ADDENDUM NO. 2

TO: ALL BIDDERS OF RECORD
PROJECT: ROCK CREEK & SWAMP CREEK STOCK TANKS
FWP PROJECT #: 12-28
DATE: July 12, 2012
FROM: Paul Valle, Project Manager

PIPELINE DRAIN VALVE
PLAN VIEW NTS

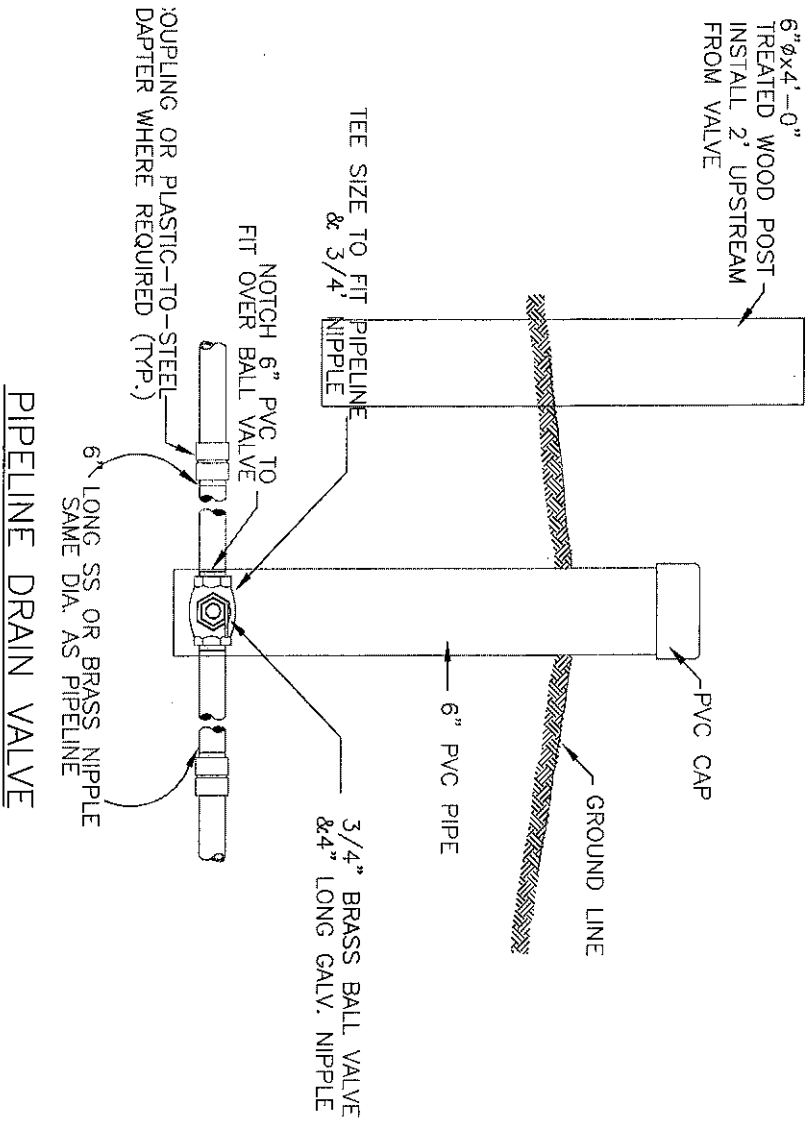
- 1) Clarification – Construction will not be able to start until after September 15, when irrigation water can be shut down.
- 2) Clarification – The first set of five (5) stock tanks will be located at approximately the pipe corner indicated on the plan.
- 3) Clarification – The tanks shall be installed 15 feet apart.
- 4) Clarification – Preparation for tank installation will require over excavation and the addition of six (6) inches of pit run gravel.
- 1) Modification – Use revised proposal form included in Addendum #2.
- 2) Modification – Bid Item #3, the owner will provide eight (8) of the required rubber tire stock tanks. Contractor will need to transport the eight (8) tanks from Dillon, MT to the project site.
- 3) Modification – Bid Item #2, the pipe size is modified to 1 ½" HDPE pipe.
- 4) Modification – Bid Item #5, drains are detailed in the attached detail schematic.
